THE ANNEX

APARTMENT COMMUNITY

SITE PLAN FOR PLANNING COMMISSION

Administrative Amendment Narrative

THE ANNEX
 AMENDMENT FOR PLANNING COMMISSION
 LANDSCAPE PLAN (NORTH)

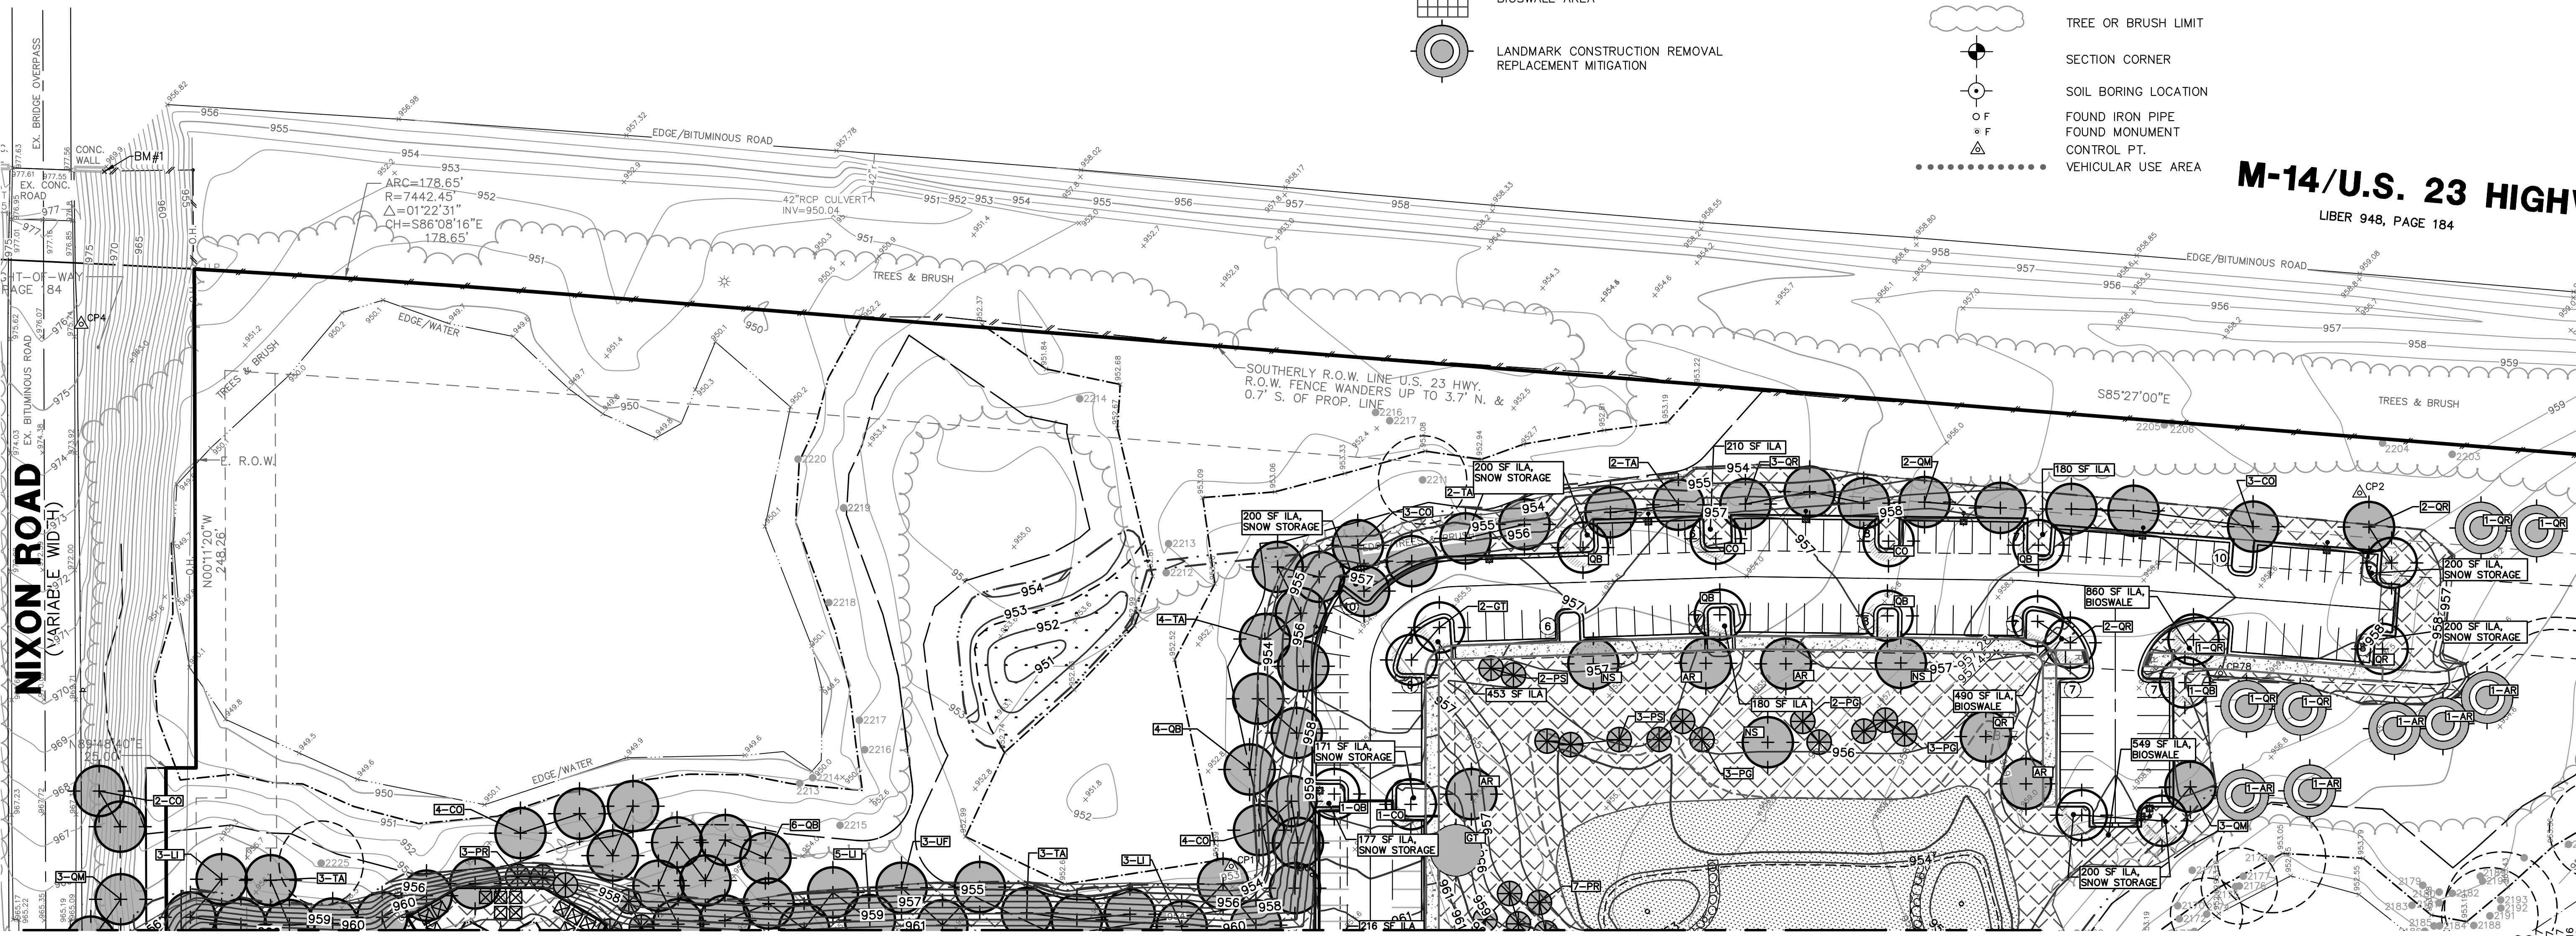
Sheet 13 & 14: The same number of proposed planting are shown. Some have been relocated around the north detention basin in the area of the building that was eliminated.

The Natural Features Protection plan has been revised. A landmark tree, tree #2270, a 17" white oak, along the Nixon Road frontage was removed during the construction process. This was done once the south entrance was placed, there was not adequate sight distance. It was removed for safety reasons. Mitigation in the form of tree replacement has been shown in this submittal at a 200% replacement, or 34" of replacement inches. This is accomplished with 14 - 2.5" caliper trees, 7 red maple and 7 red oak shown on sheets 13 and 14.
